## **Public Testimony: Willow Ridge Geologic and Hydrologic Risk Parameters**

### **Willow Ridge Proposed Development 4096 Cornwall St., West Linn, OR Tax Lot: 6300**

This document provides an assessment of geologic and hydrologic risk related to the proposed Icon Construction and Development (ICON) project on Tax Lot 6300 (Willow Ridge Development). The testimony provided herein was produced by William House on a pro gratis basis for the residents of various communities surrounding the proposed Willow Ridge development. The testimony provides an assessment of available technical data to determine geological and hydrological risk parameters associated with the development and assess risk mitigation plans.

Exhibit 1

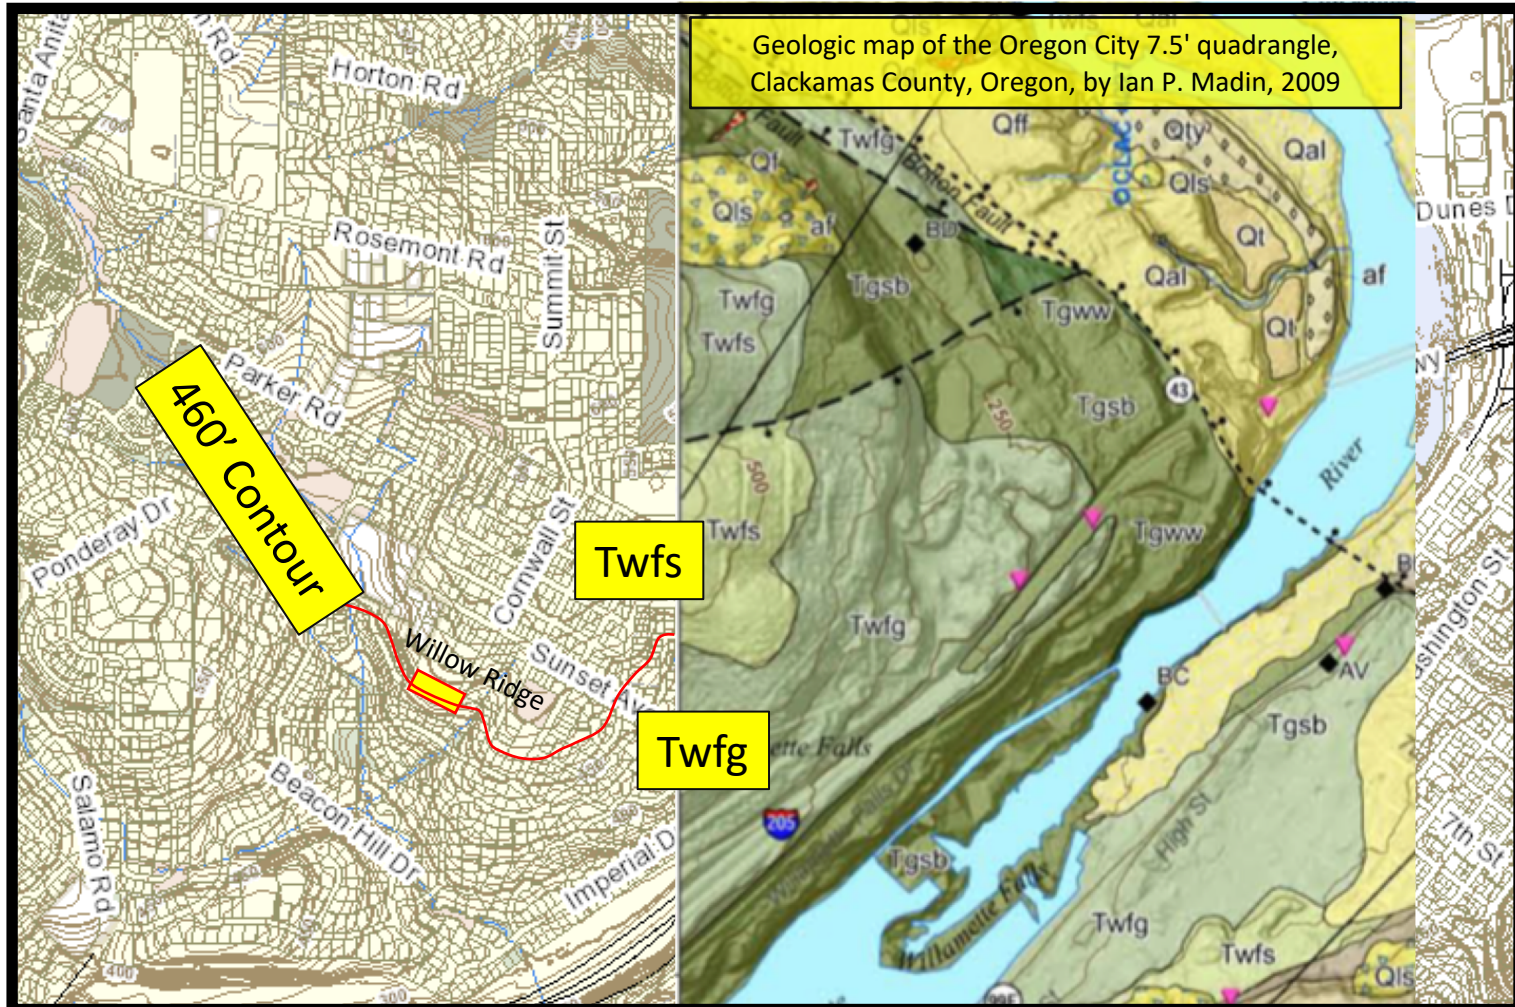
The Frenchman Springs member is divided into the upper Sandy Hollow Unit (Twfs) and the lower Gingko Unit (Twfg) (Exhibit 1a). The contact between this units occurs at 460' ASL on the western edge of the Oregon City Quadrangle geological map. The tabular nature of these units allows a reasonable interpretation that the contact will be at the same level 1,570 feet to the west of the geologic map in the Willow Ridge development (Exhibit 1).

Maps showing the extension of the contact between the Sandy Hollow and Gingko units of the Frenchman Springs member of the Wanapum Basalts

# Wellbore Profile: 4197 Reed Street

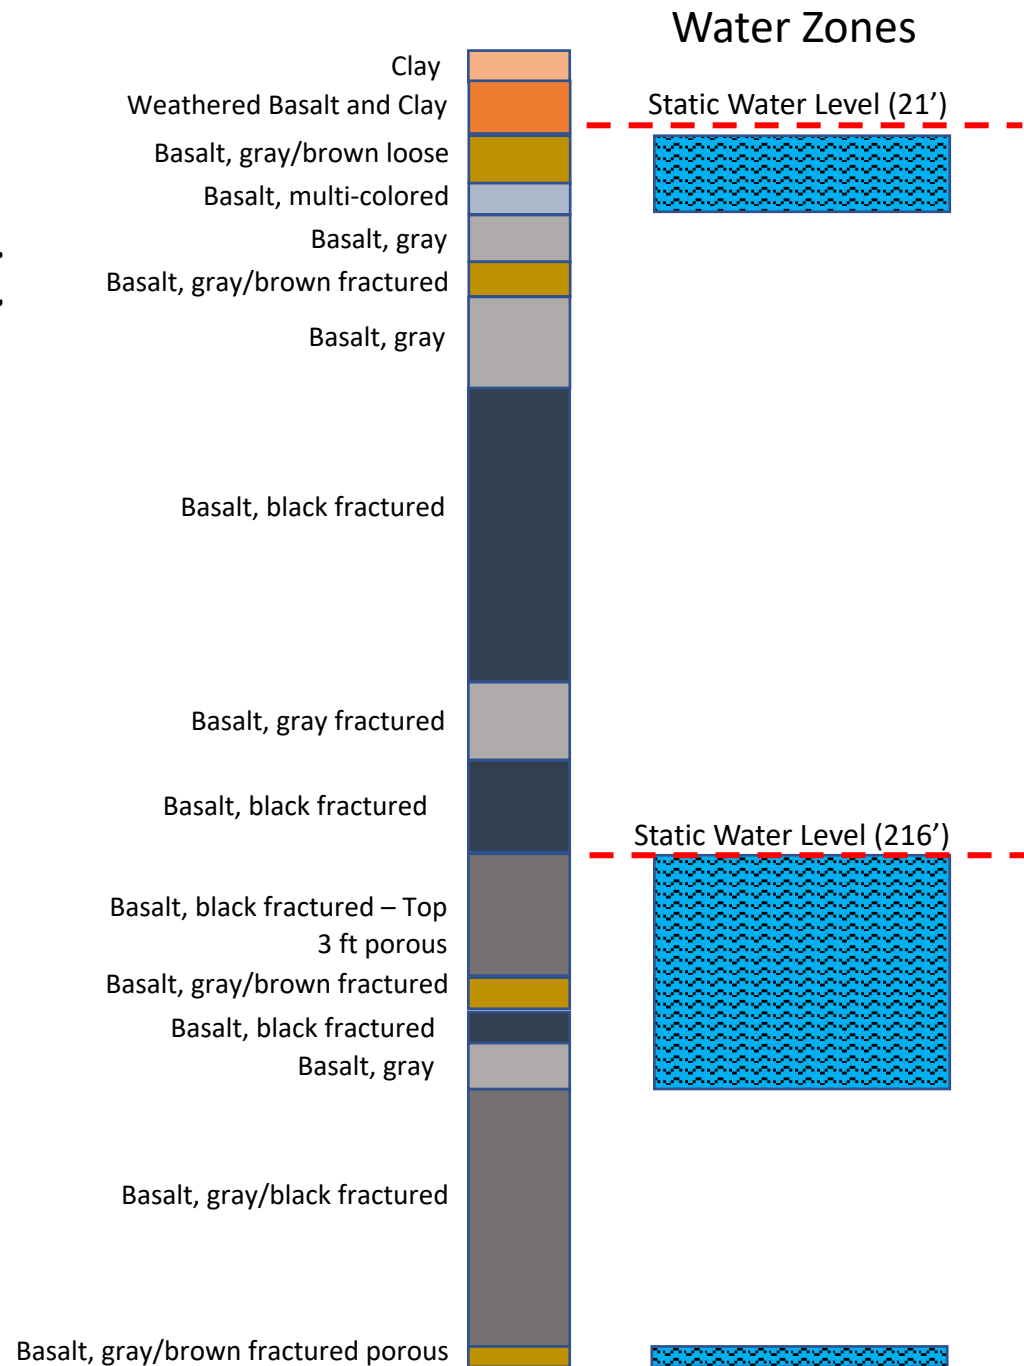
The base of the water-bearing zone is 462 feet ASL. This correspond closely with the projected geological contact between the upper and lower Frenchman Springs units. Below this contact gray basalts followed by gray/brown fractured basalts were encountered. The next water zone in the well was encountered between 216 – 280 feet ASL.

Perched water was encountered in this well with a floor at 46 feet below ground level or an elevation of 462 feet asl

# Estimated Water Flow Zone based on the Reed Street Well (Uses terrain contours from MapOptix)

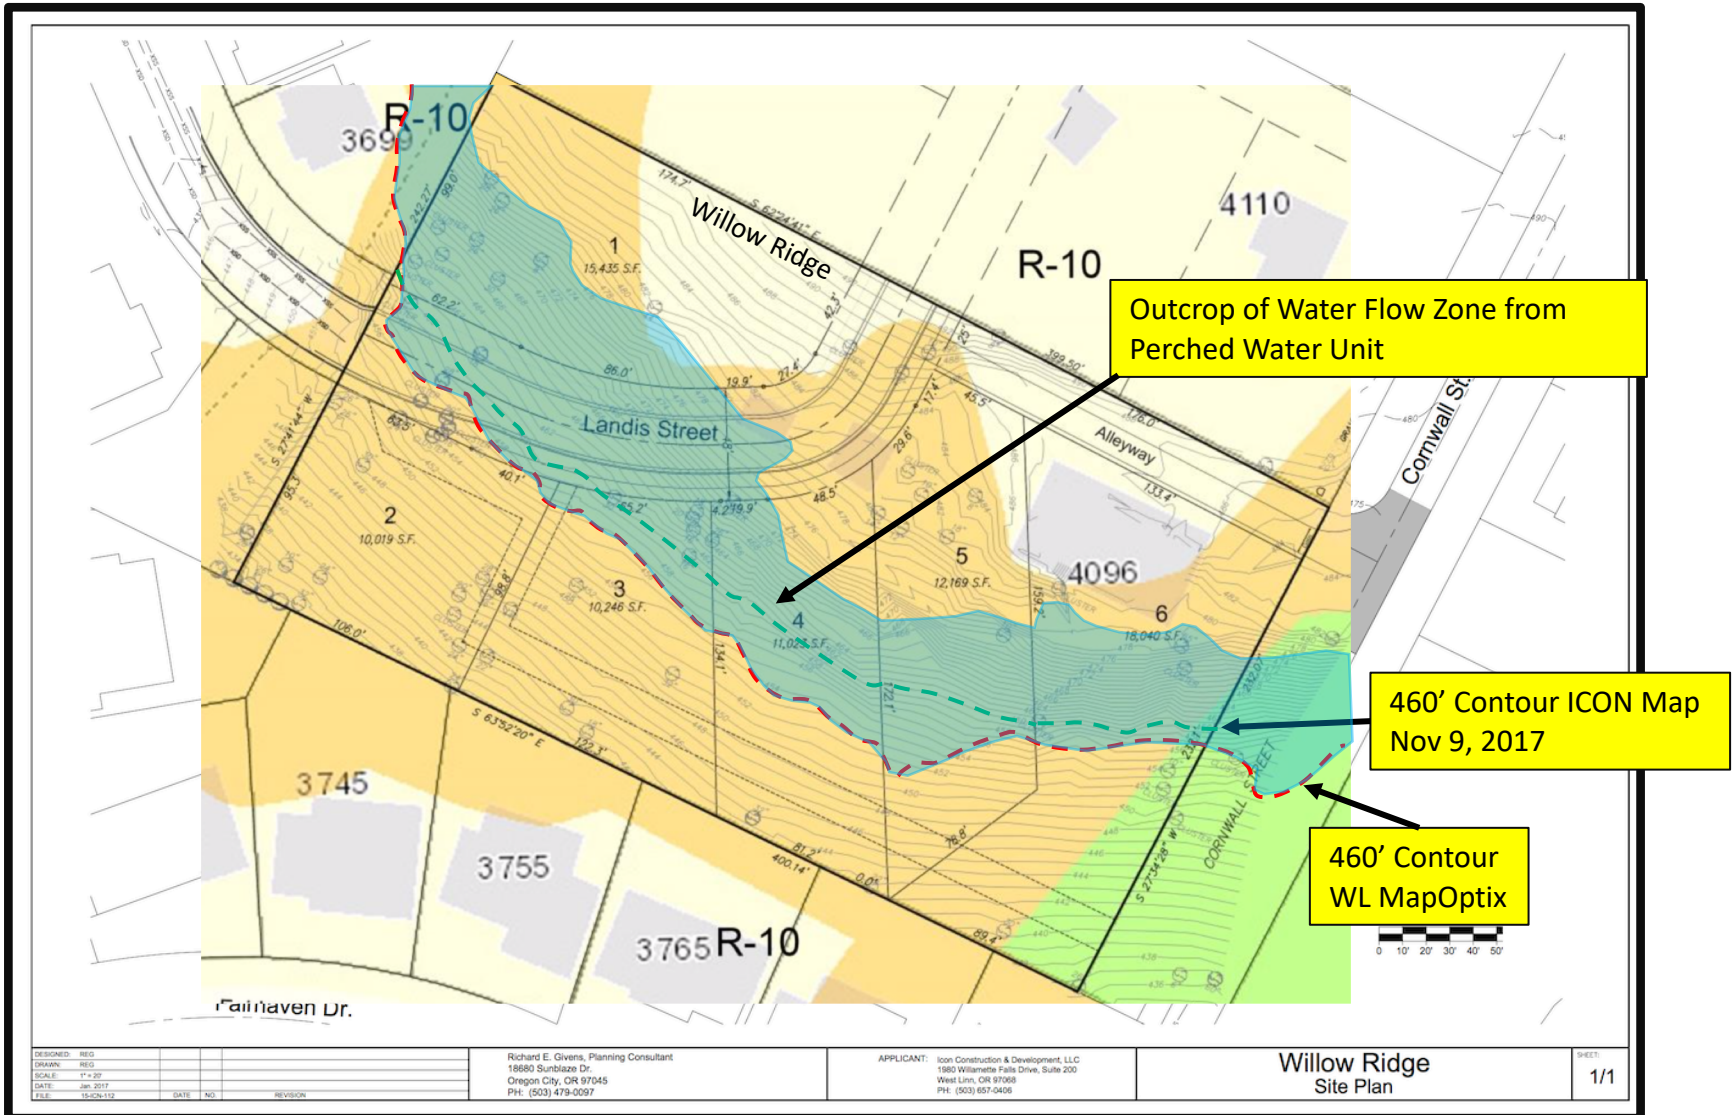
The steep slopes of the Willow Ridge Development represent an area where the topography cuts through the Frenchman Springs basalts and exposes the perched water unit to the surface. The water zone cuts across the development area in a generally NW-SE line, following the topography between 460 – 480 feet asl (Exhibit 6).

The water zone map in Exhibit 6 was constructed using the MapOptix contours. The exhibit denotes differences between the MapOptix 460 foot contour and the ICON maps used in their original planning application.

Reasons for differences between the ICON map contours and the MapOptix terrain contours are unknown

# Geologic Cross Section (Profile)

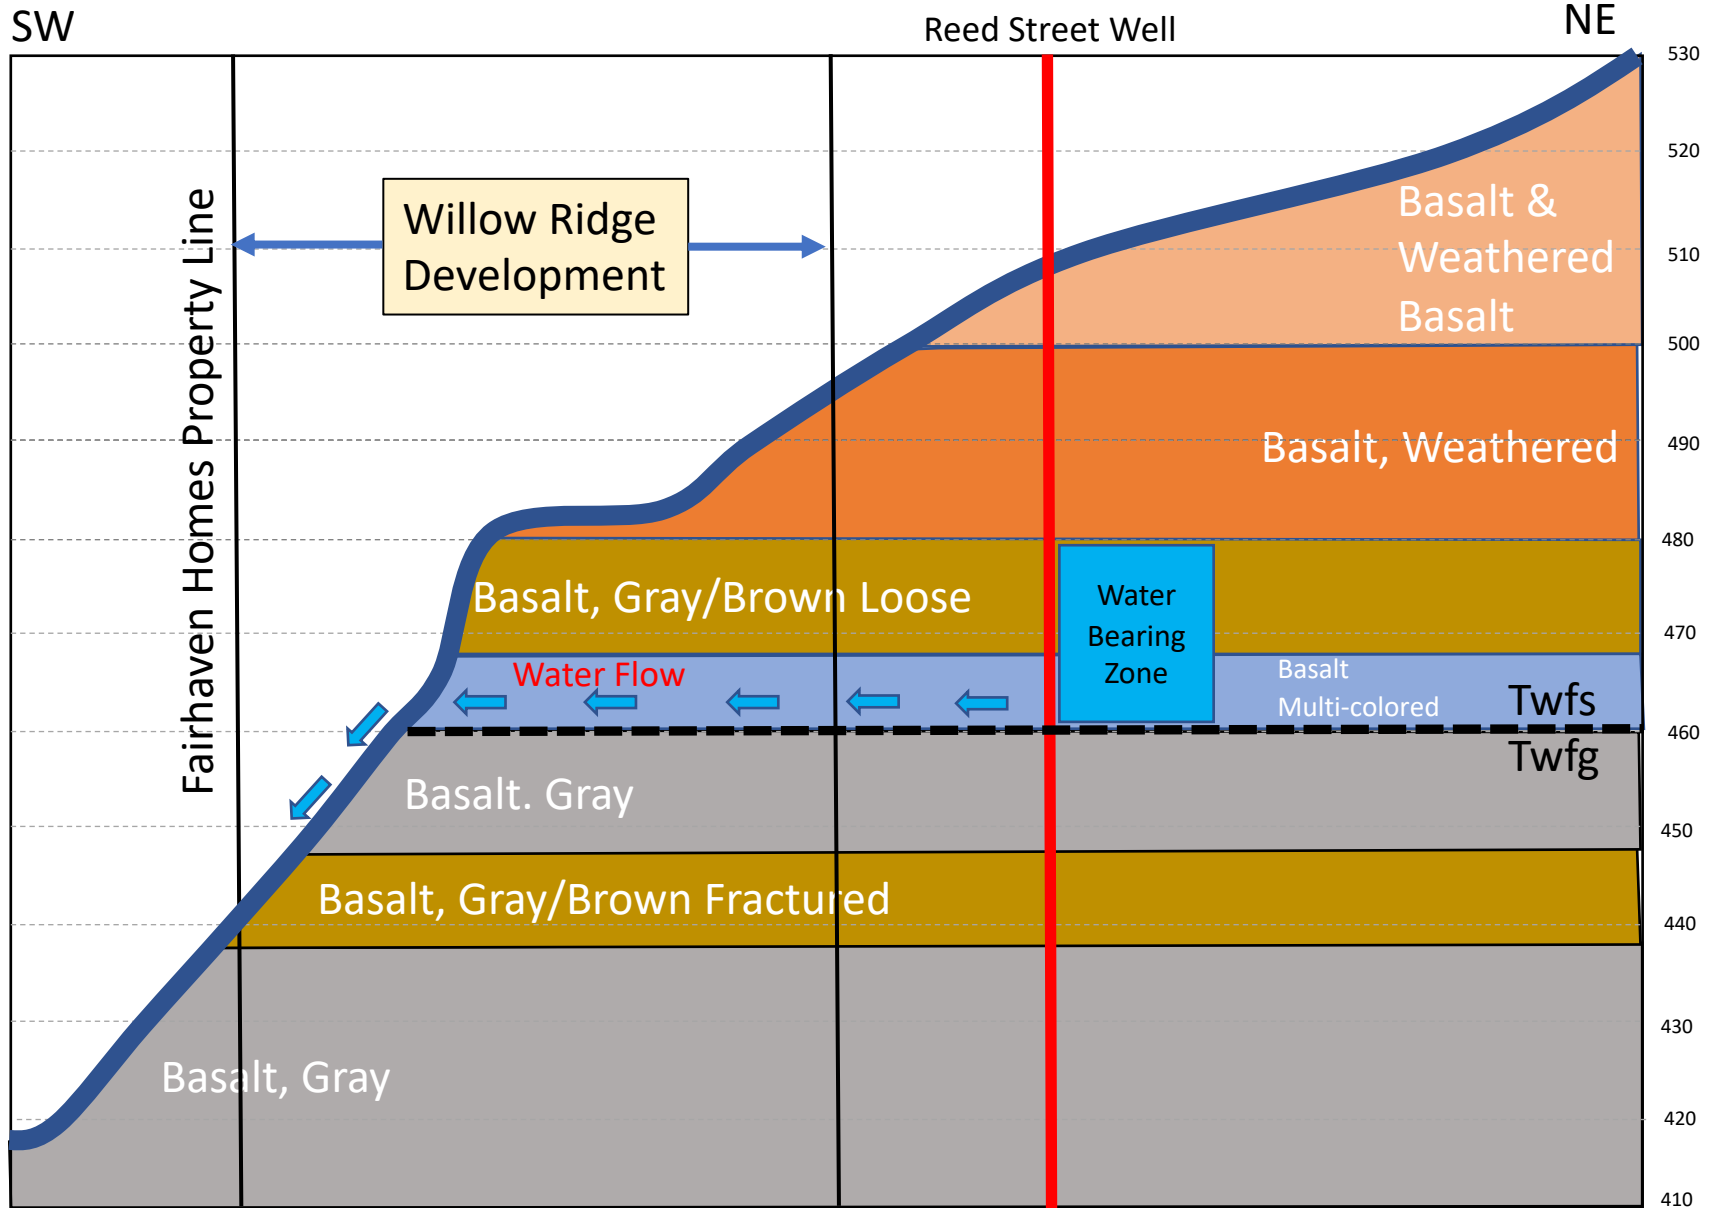
A cross sectional representation of the local geology and the perched water zone is shown in Exhibits 7 & 7a. The diagram shows the natural water flow from the subsurface to the surface

The dynamics of this natural water flow system are such that water enters the system via precipitation on the ground surfaces above the 460 foot contour. The water migrates vertically into the soils until it reaches the top of the gray basalt layer at about 460 feet ASL. This layer forms a permeability barrier and the water accumulates as a perched aquifer. The free surface along the Willow Ridge slope provides an exit point for the water and allows the aquifer to drain (Exhibit 7).

## Public Testimony Dec. 2017:

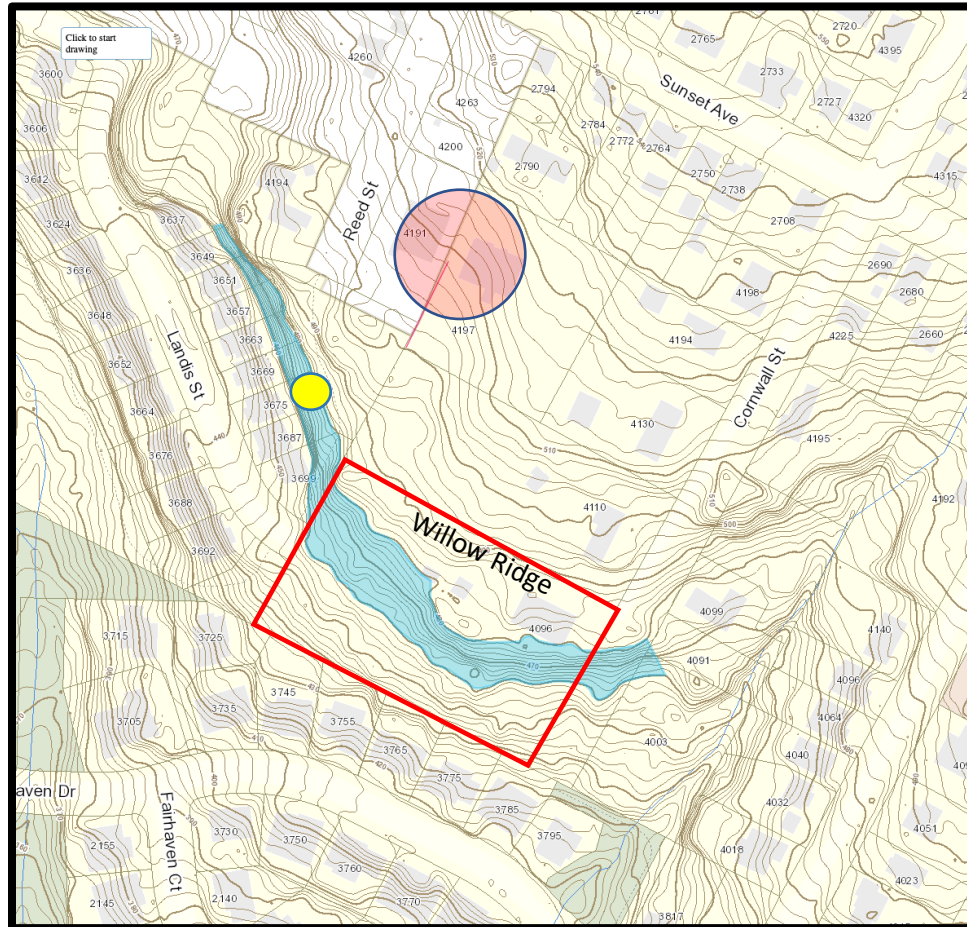
Previous public testimony from Stonegate residents has demonstrated the relationship between drainage changes due to upslope construction and increased water flow from the perched water zone (2017 testimony by Chelsea Diaz). The perched water table outcrops behind the Diaz home, and flooding problems from that zone coincided with upslope construction (Exhibit 8).

Public testimony in 2017 by Chelsea Diaz demonstrated a clear connection between upslope changes in drainage cause by construction and the subsequent increased water flow from the same geological formations that occupy the Willow Ridge Development slopes. The location of this incident was immediately to the NW of the Willow Ridge plot in the Stonegate community. The perched water table outcrops behind the Diaz home, and flooding problems from that zone coincided with upslope construction (Exhibit 8).

"After two homes behind and above us began construction located at 4191 Reed Street and 4197 Reed Street, I noticed water streaming between the boulders in my 25 foot retaining wall into my back yard. I then began an lengthy process of trying to find where the water was coming from. After a landscape developer investigated the issue, he determined that a new spring had formed in the upper tier of my back yard."

This demonstrates the clear connection between construction and changes in drainage above the slope and increased water flow through the "water flow zone" marked in blue.

# Shallow Landslide Risk – Oregon State Department of Geology and Mineral Industries

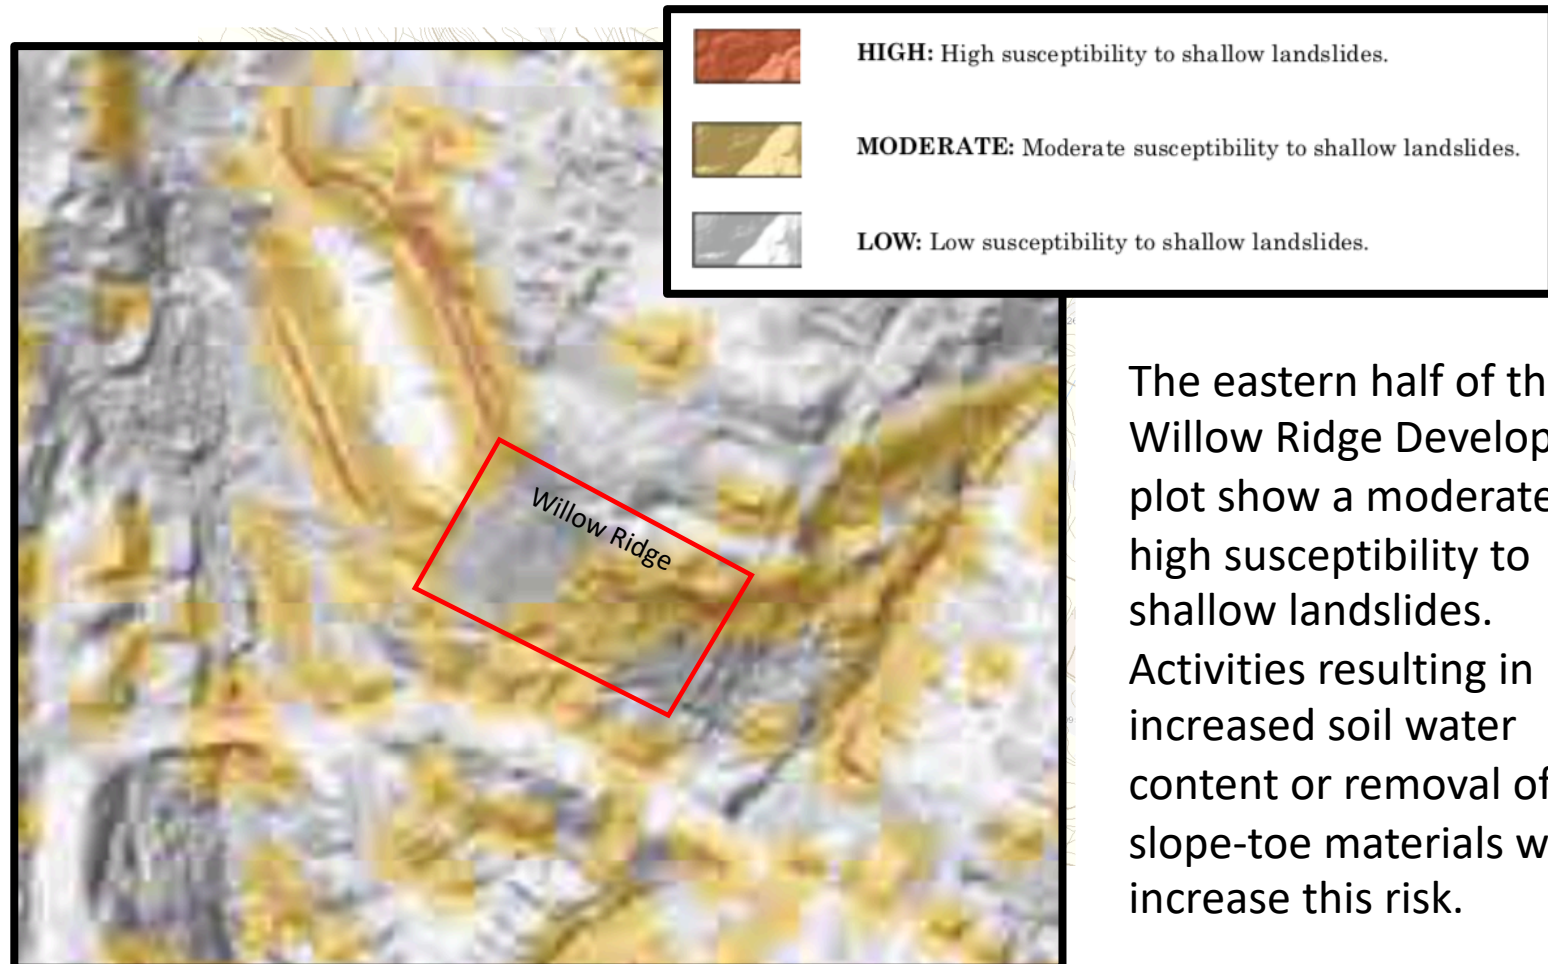
The eastern half of the Willow Ridge Development plot is shown on Oregon State Department of Geology and Mineral Industries Shallow Landslide maps as having a moderate to high susceptibility to shallow landslides (Exhibit 9). Any construction activities resulting in increased soil water content or removal of slope-toe materials will increase this risk.

The eastern half of the Willow Ridge Development plot is shown on Oregon State Department of Geology and Mineral Industries Shallow Landslide maps as having a moderate to high susceptibility to shallow landslides (Exhibit 9). Activities resulting in increased soil water content or removal of slope-toe materials will increase this risk.

The eastern half of the Willow Ridge Development plot show a moderate to high susceptibility to shallow landslides. Activities resulting in increased soil water content or removal of slope-toe materials will increase this risk.
